SERVICE BULLETIN

SB-121924-A

ID NUMBER & REVISION: SB-121924-A
SUBJECT: (MANDATORY) Redressal of ROTAX SB-912i-015iS Mandatory Inspection and Replacement of Expansion Tank Assy
RELEASE DATE: 22 January 2025
EFFECTIVE DATE: 22 January 2025
SUPERSEDES NOTICE: N/A
AIRCRAFT AFFECTED: **MAKE & MODEL:** ICON A5
SERIAL NUMBERS: 00001-00224
REQUIRED ACTION: Inspect and/or replace the ROTAX Expansion Tank Assy in accordance with ROTAX SB-912i-015iS. **This is mandatory.**
TIME OF COMPLIANCE: Refer to ROTAX SB-912i-015, Section 1.5:

Inspection and/or replacement of expansion tank assy. for ROTAX® 912, 914, 912 i, 915 i and 916 i (Series) Aircraft Engines

Fig. 1

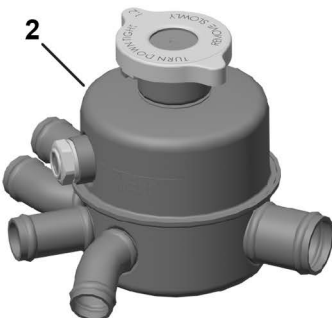
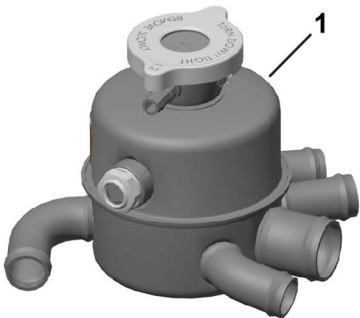
Due to a deviation in the manufacturing process, the individual components of the expansion tank assy. may not be sufficiently welded. Sealing of the assy. may be compromised and coolant leakage and subsequently an overheating of the engine may occur.

Fig.1/ pos.	part no.	Qty/ engine	Description
1	922668	(1)	EXPANSION TANK ASSY.
2	922666	(1)	EXPANSION TANK ASSY.
-	-	AR	COOLANT (as specified in the latest Service Instruction SI-912-016, SI-914-019, SI-912 i-001, SI-915 i-001,SI-916 i-001)

Fig. 3

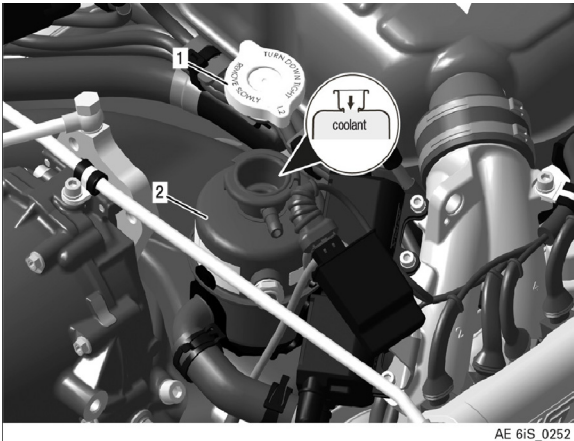
3.4.3) Inspection of expansion tank assy. - on aircraft

Step	Procedure
1	If necessary, clamp closed the hose to the coolant overflow bottle.
2	Remove the radiator cap from the expansion tank.
3	Drain coolant until bottom of the expansion tank assy. is clearly visible.
4	Perform an internal visual inspection of the expansion tank assy. using a bore-scope or similar optical device.
5	If the visual inspection shows consistent welding, the expansion tank assy. is serviceable (See Fig. 5), continue with step 7.
6	If any connection has inconsistent or missing welds, the expansion tank assy. is unserviceable and must be replaced (See Fig. 6), continue with section 3.5.2).
7	Refill coolant into the expansion tank. See Maintenance Manual Line Chapter 12-10-00 section Coolant check/replenish. See also SI-912 i-001,SI-912-016,SI-914-019, SI-915 i-001,SI-916 i-001, current issue. NOTE: If the engine is equipped with a thermostat valve, follow the manufacturer's instructions.

8	Apply small amount of coolant to rubber surfaces inside radiator cap (provides lubrication to prevent binding). Tighten the radiator cap by hand.
9	Perform an engine test run and check for leaks. Replenish with clean coolant as required. See Maintenance Manual Line Chapter 12-10-00 section Coolant check/replenish.
10	Make an entry in the engine logbook stating the execution of this Service Bulletin and the inspection findings. Continue with section 3.6)

Fig. 4

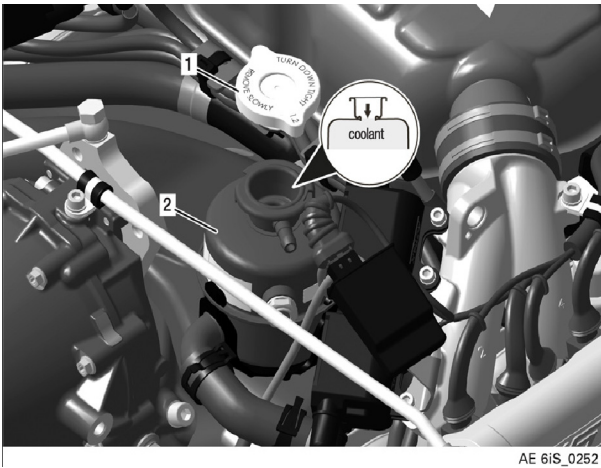
3.5.2) Replacement of expansion tank assy. on aircraft

Step	Procedure
1	Please see current Maintenance Manual Heavy (MMH) for the respective engine type, Chapter 75-00-00 Expansion tank and form hoses removal/installation
2	Refill coolant into the expansion tank. See Maintenance Manual Line Chapter 12-10-00 section Coolant check/replenish. See also SI-912 i-001,SI-912-016,SI-914-019, SI-915 i-001,SI-916 i-001, current issue. NOTE: If the engine is equipped with a thermostat valve, follow the manufacturer's instructions.
3	Apply small amount of coolant to rubber surfaces inside radiator cap (provides lubrication to prevent binding). Tighten the radiator cap by hand.
4	Perform an engine test run and check for leaks. Replenish with clean coolant as required. See Maintenance Manual Line Chapter 12-10-00 section Coolant check/replenish.
5	Make an entry in the engine logbook stating the execution of this Service Bulletin and the inspection findings.
